Office Action Summary	Application No.		Applicant(s)	
	10/520,463		DI TRAPANI, AGOSTINO	
	Examiner		Art Unit	
	Jessie Fonseca		3637

DETAILED ACTION

Fig. 3: Khamis (US 6,050,749)

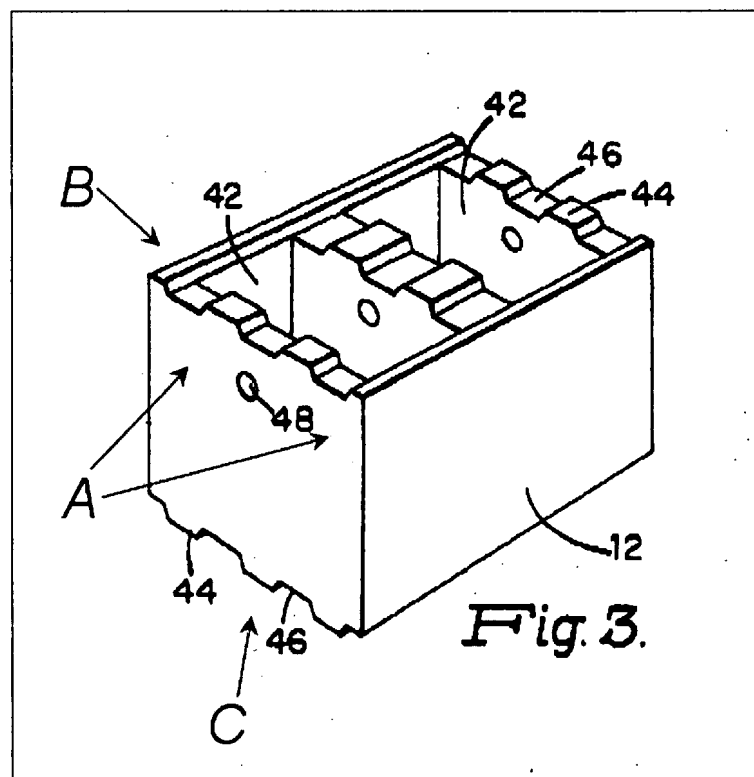
With regards to claim 38 and 41: Khamis discloses a wall (fig. 2 and 6) constructed from a plurality of construction elements (12) made of concrete like material (col. 3, lines 41-46), each construction element (12) comprising an upper face (B), a lower face (C), and lateral faces (fig. 3), the construction element (12) comprising at least one groove (46) extending over the upper face (B) thereof, the groove (46) being associated with a load-bearing wall or partition (A) of the construction element (12) and arranged at a distance from an outer lateral edge of the construction element (12), the construction element (12) further comprising at least one protuberance (44), which extends over the lower face (C) thereof, the protuberance (44) being arranged in such a way that when a first construction element (12) of the plurality is superimposed on a second construction element (12) of said plurality within said wall, the protuberance (44) of the first construction element (12) extends in the groove of the second construction element (12) (fig. 6).

With regards to claim 39 and 42: Khamis, in view of Breaky or Stewart Jr., further discloses the protuberance (44) and the groove (46) have a cross-section, which is approximately trapezoidal in shape (fig. 3), in such a way that, a protuberance lateral flank of the first construction element (12) extends approximately parallel to a groove lateral flank of the second construction element (12) (fig. 3 and 6), and a small base of the trapezoid of the protuberance (44) being arranged opposite a small base of the trapezoid of the groove (46) when they are engaged (fig. 3 and 18). As per the modification of claim 37, the lateral flanks are arranged in such a fashion as to have first space between them, in which a binder is disposed within, the small bases being arranged in such a way where binder is disposed in the second space as created by the grooves.

With regards to claim 45: Khamis, in view of Breaky or Stewart Jr., further discloses the width of the groove (46) of the construction element (12) is less than the thickness of the load-bearing wall or partition (A) of the construction element (12) (fig. 3).
